Downtown Development Review Overlay (DDRO) District

Report to the Committee

Case No: 24-OVERLAY-0016
Classification: Non-Expedited
Meeting Date: June 18, 2024

Property Address: 707 York and 726, 730, 734, 736 S 7th Streets

Site Plan

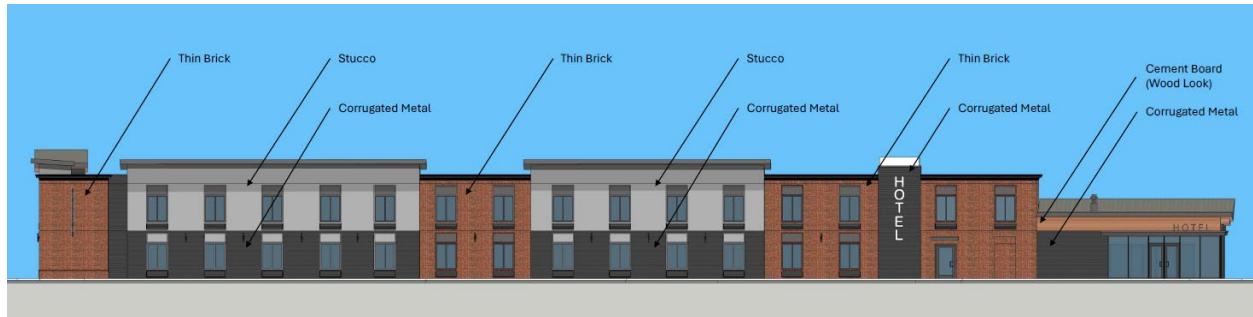
Staff recommends the open space be developed in a way to provide either public access or amenity space for the hotel/motel guests. Details like fencing, patio or walkways, public art, or additional landscaping is encouraged in this area. Staff also request information regarding the interim treatment to the area set aside for the later phase hotel building.

- 5. Details regarding the design of the open space at the northwest corner of the subject site, including but not limited to potential fencing/gates, furnishings, patios or walkways, lighting, or public art, shall be provided to staff for review and approval prior to construction.**

S 7th (East) Façade

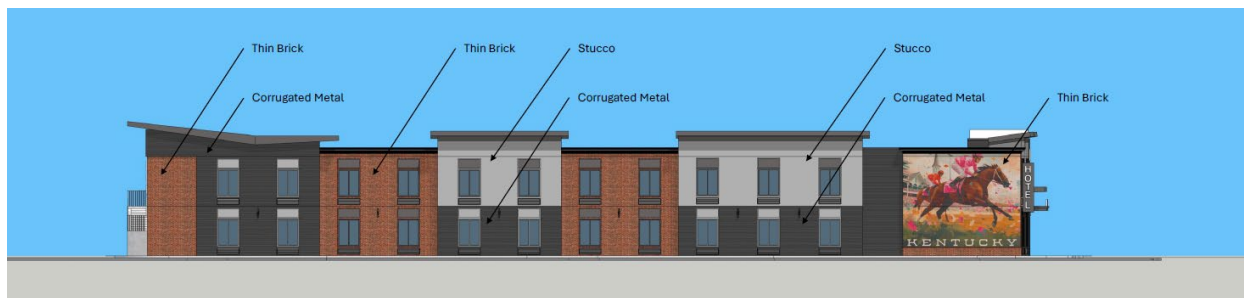
- 1. All glass on the ground level of the S 7th and York Street facing facades shall be clear. Front glass shall not be tinted, smoked, or have added reflection or mirroring. If the glass is low-E, it shall be clear.**
- 2. The applicant shall consider the installation of a glass person door with awning on the south York Street façade accessing the southeast stairwell. If included, the applicant shall submit an updated elevation to Planning staff for review and approval.**
- 3. Rooftops shall not look cluttered from any pedestrian vantage point. All mechanical or utility equipment shall be well-integrated into the overall design.**
- 4. Exterior lighting details shall be provided to staff for review and approval prior to construction taking place.**

York (South) Façade

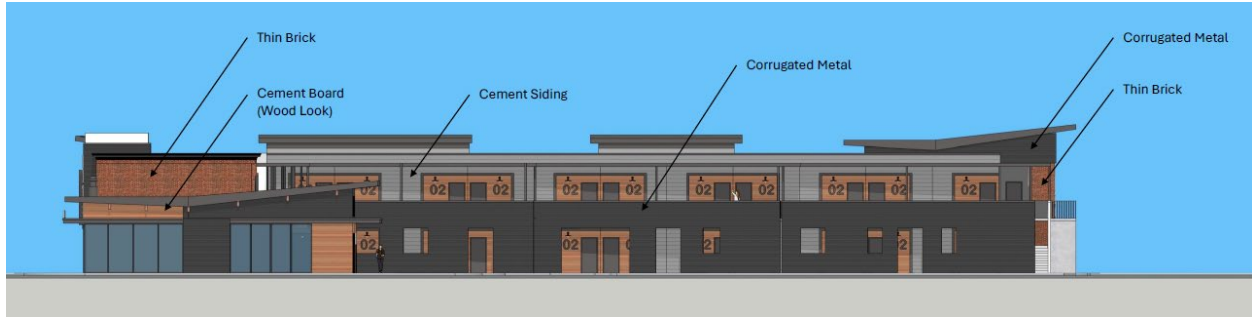
The new motel building will include 48 rooms, 24 on each floor. It is contemporary in style and has architectural details that are common of other modern motel/hotel projects. The materials of brick, horizontal metal siding, stucco, and wood look cement board are compatible with the surroundings on the southern fringe of the district. The design places some emphasis on the corners, having these portions of the building serve as focal points through height changes, unique roof shapes, public art, or wrap around storefront glass to define the main entrance. However, there is only one main entrance and one secondary entrance facing a street, both located to the north of the motel building facing S 7th. Staff highly recommends at least one more door and awning, similar in style and design to the secondary door proposed on S 7th, be added along York Street to access the southeastern stairwell. It is not required to be a public access door or unlocked at all hours, but could be an emergency exit or key card access door. The presence of a door/entry in this location would make the overall design more compatible with the guidelines.
